HERITAGE IMPACT STATEMENT

166 Pittwater Rd, Manly NSW

Issue C: 6.12. 2022

Photo 11: View from the side of the house looking towards the front with the storage element located behind the side gate. The unit is not shown on the existing and proposed plans DA//05 & 06.

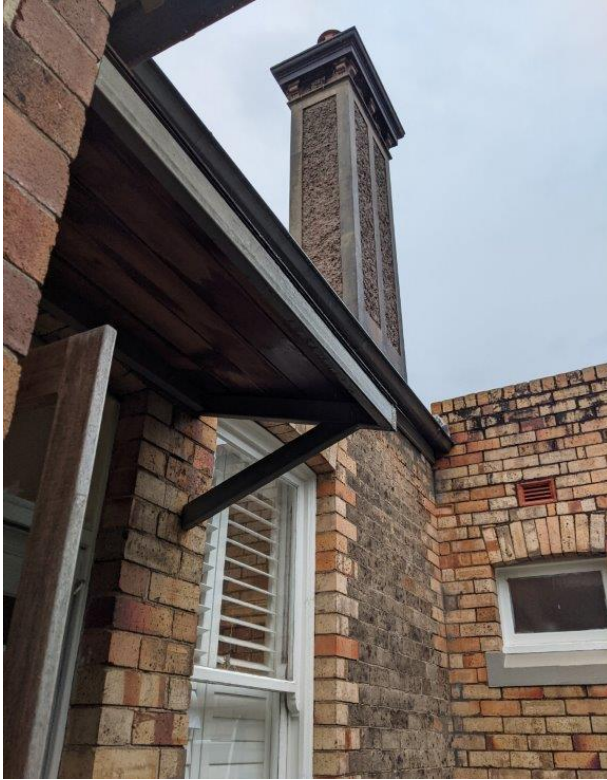
Drawings DA05 & 06 do not illustrate the existing rear of the building with remnant brick wall to north side of deck and do not show the existing storage unit to the front southern side of the building

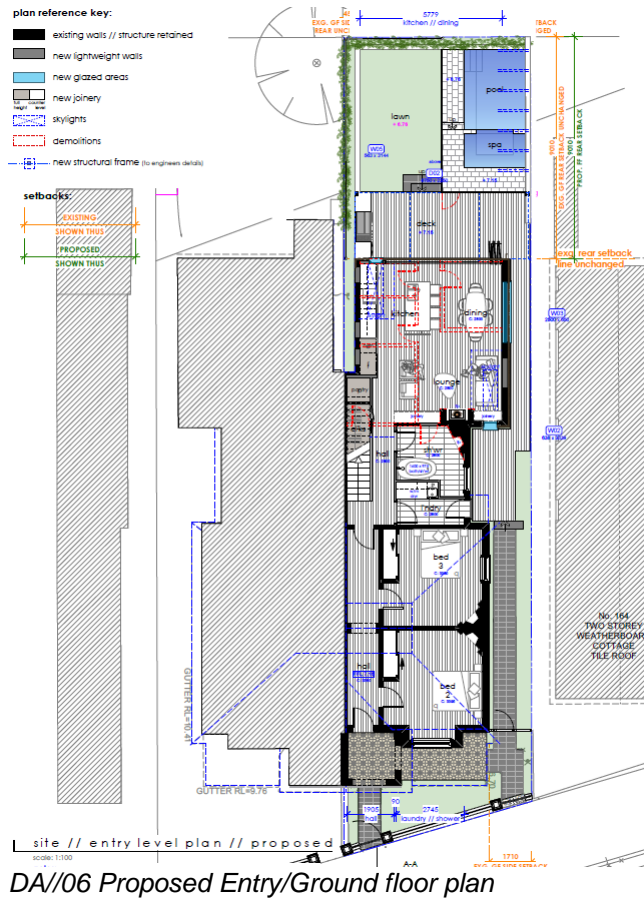
Drawing DA06 illustrates the extent of the demolition work proposed

- Demolish the fireplace in the living room and doors to the rear of the house and third bedroom
 - The revised Floor plan indicates retention of the fireplace in the Lounge Room and retention of the door to the third bedroom while the original door from the Living room into the dining room is infilled to accommodate the bathroom and Lounge room joinery. The original opening is however capable of interpretation within the finishes.

- Demolish the fireplace to the dining room and wall defining the third bedroom
 - The revised Floor plan shows retention of the fireplace to the dining room. While door to the rear of the original house is removed for access next to the proposed stair, this can be interpreted with a bulkhead

- Demolish the windows to the third bedroom, kitchen and bathroom on the north elevation
 - The revised drawings DA//06 and 10 indicate that these original windows are to be infilled to accommodate the new kitchen. This intent is taken from the plan as the Elevation DA//10 does not show these original external features as they are largely concealed from view by their location as part of the nature of the light well and adjoining semi-detached property. The three windows are capable of interpretation within the infill detailing.

- Demolish the rear external eastern wall to the deck
 - The existing brick wall to the northern end of the deck is not indicated on the existing or proposed plans. Despite it being a minor element, it is clearly original material and forms part of the dwelling as is indicated by the adjoining similar semi-detached house and is capable of retention as part of the existing/proposed barbecue
